## ADDENDUM #4

Date: April 24, 2025

Project: Tierney Park Improvements Project

Owner: Village of Lexington, Michigan

**RAILING INNER FACE ELEVATION**

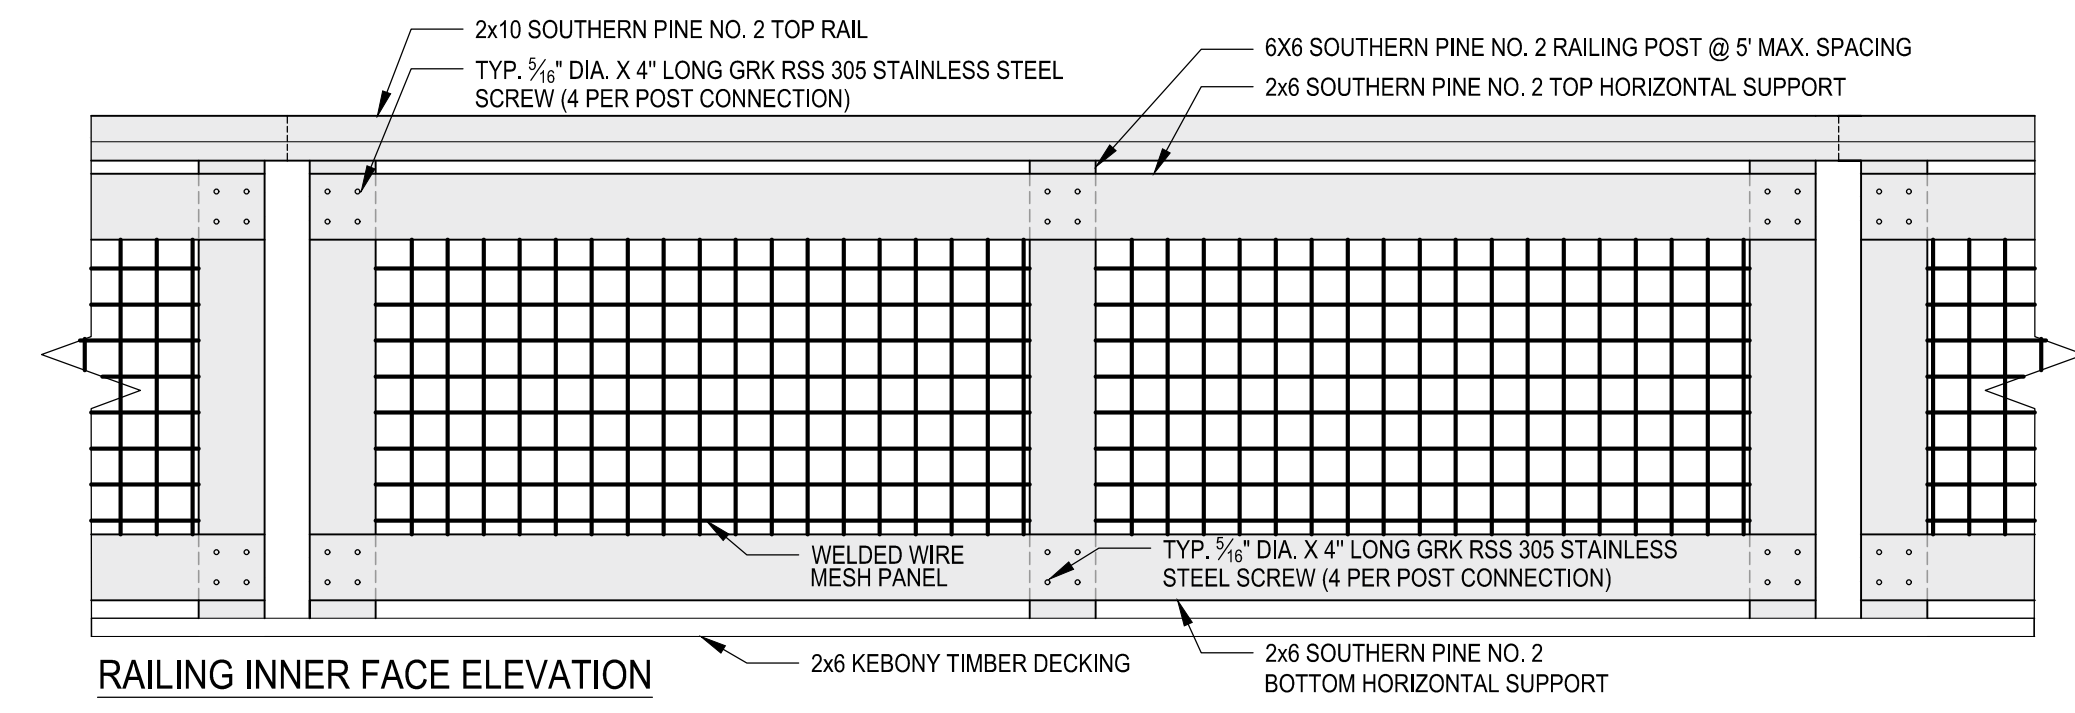
1. **SM-5.03** Structural Marine Details
  - a. Boardwalk Railing details have been updated.
